Product Change Notice (PCN)

PCN Number: **PCN-0451162R-01**

Product(s) Affected: PJ-040CH

PREVIOUS CUI DEVICES DETAIL / IMAGE	NEW CUI DEVICES DETAIL / IMAGE

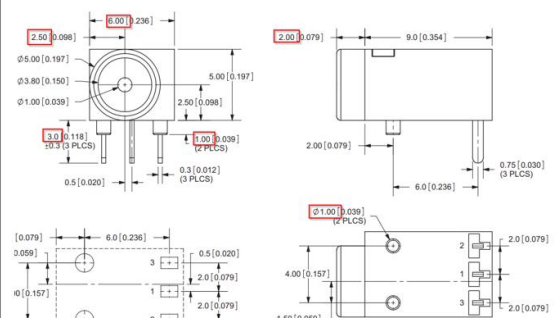
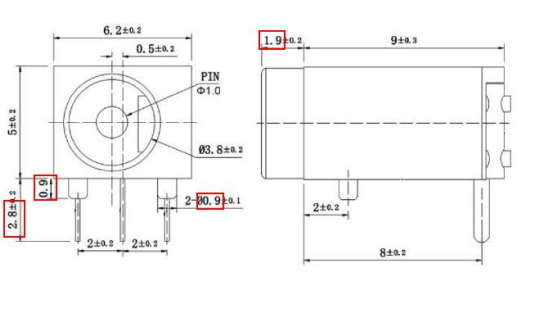
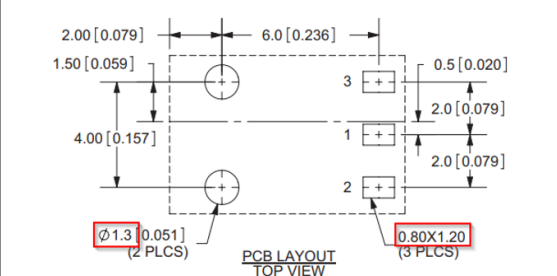
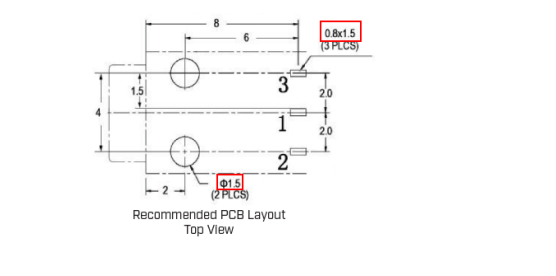
Description of Change: mechanical, material differences as shown below:

<p style="text-align: center;">PCB LAYOUT TOP VIEW</p>	 <p style="text-align: center;">Recommended PCB Layout Top View</p>																																							
<table border="1"> <thead> <tr> <th></th> <th>MATERIAL</th> <th>PLATING</th> </tr> </thead> <tbody> <tr> <td>center pin</td> <td>brass</td> <td>silver</td> </tr> <tr> <td>terminal 1</td> <td>brass</td> <td>silver</td> </tr> <tr> <td>terminal 2</td> <td>copper alloy</td> <td>silver</td> </tr> <tr> <td>terminal 3</td> <td>brass</td> <td>silver</td> </tr> <tr> <td>plastic</td> <td>PA66</td> <td></td> </tr> </tbody> </table>		MATERIAL	PLATING	center pin	brass	silver	terminal 1	brass	silver	terminal 2	copper alloy	silver	terminal 3	brass	silver	plastic	PA66		<table border="1"> <thead> <tr> <th>DESCRIPTION</th> <th>MATERIAL</th> <th>PLATING/COLOR</th> </tr> </thead> <tbody> <tr> <td>center pin</td> <td>brass</td> <td>silver</td> </tr> <tr> <td>terminal 1</td> <td>brass t=0.25</td> <td>silver</td> </tr> <tr> <td>terminal 2</td> <td>brass t=0.25</td> <td>silver</td> </tr> <tr> <td>terminal 3</td> <td>brass t=0.25</td> <td>silver</td> </tr> <tr> <td>cover</td> <td>PBT (UL94V-0)</td> <td>black</td> </tr> <tr> <td>housing</td> <td>PBT (UL94V-0)</td> <td>black</td> </tr> </tbody> </table>	DESCRIPTION	MATERIAL	PLATING/COLOR	center pin	brass	silver	terminal 1	brass t=0.25	silver	terminal 2	brass t=0.25	silver	terminal 3	brass t=0.25	silver	cover	PBT (UL94V-0)	black	housing	PBT (UL94V-0)	black

MATERIAL	PLATING																																						
center pin	brass	silver																																						
terminal 1	brass	silver																																						
terminal 2	copper alloy	silver																																						
terminal 3	brass	silver																																						
plastic	PA66																																							
DESCRIPTION	MATERIAL	PLATING/COLOR																																						
center pin	brass	silver																																						
terminal 1	brass t=0.25	silver																																						
terminal 2	brass t=0.25	silver																																						
terminal 3	brass t=0.25	silver																																						
cover	PBT (UL94V-0)	black																																						
housing	PBT (UL94V-0)	black
